From: Jill Matthew [
Sent: 28 October 2021 19:56
To: Planning
Subject: Fw: NYM_2021_0687_FL FAO Miss M O'Mara

Further to your recent letter, please find amended drawing attached for the above application, The ridge and eaves height have been reduced as requested. In addition, the detailing of the dormer window is to be pantile with either lead walls or stonework to the walls.

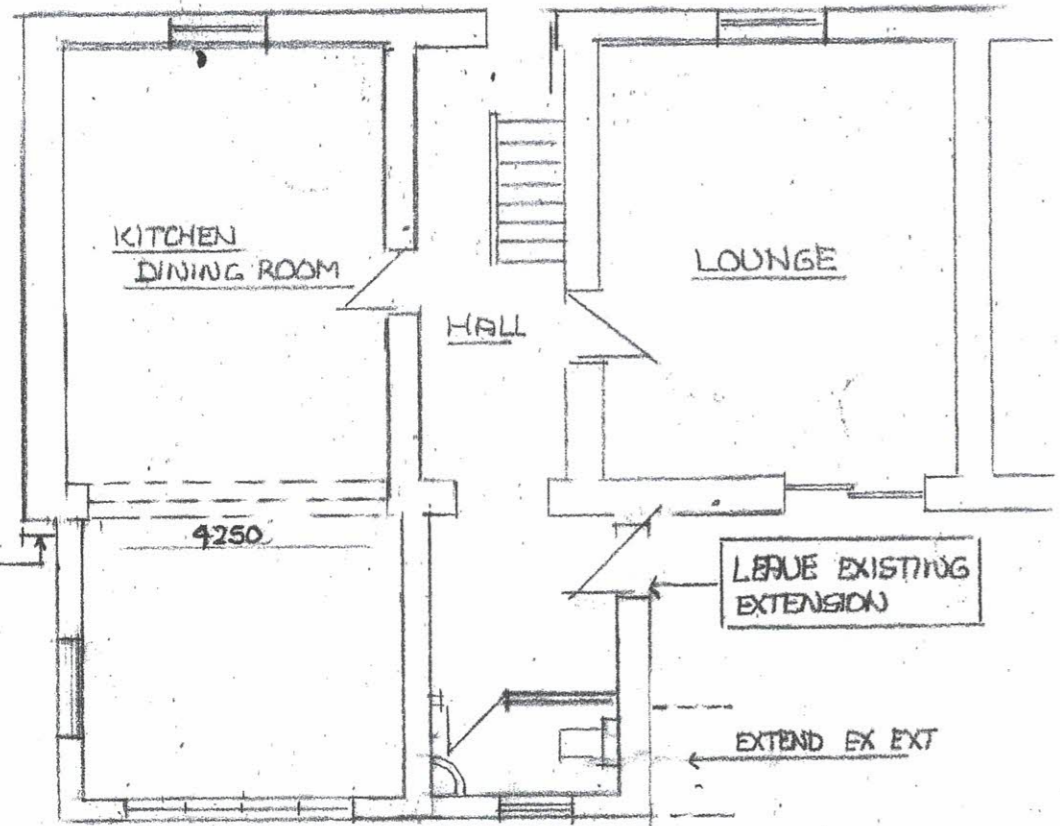
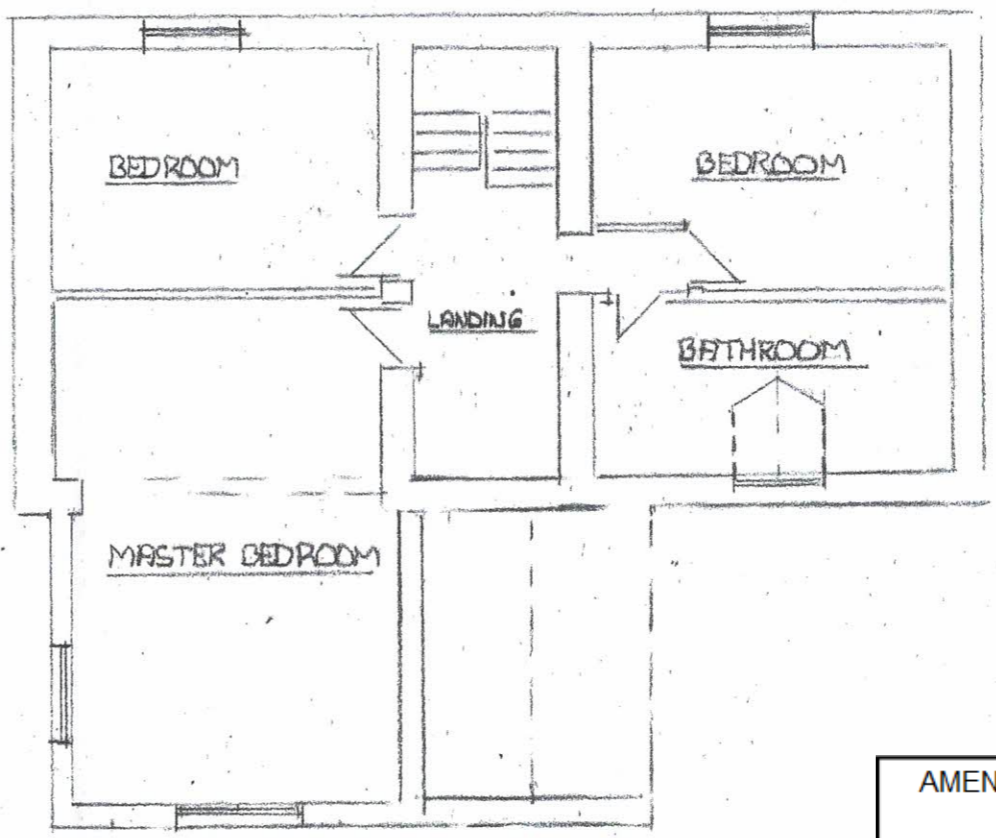
REVISE WINDOW DETAILS
TO THIS ELEVATION

LOWER RIDGE ON
EXTENSION

EDGES TO MATCH
EXISTING

LEAVE EXISTING
EXTENSION

EXTEND EX EXT

400mm

The large window detail to the west elevation has been changed with less impact on the dark skies.

Finally, the extension to the side has been moved in 400mm
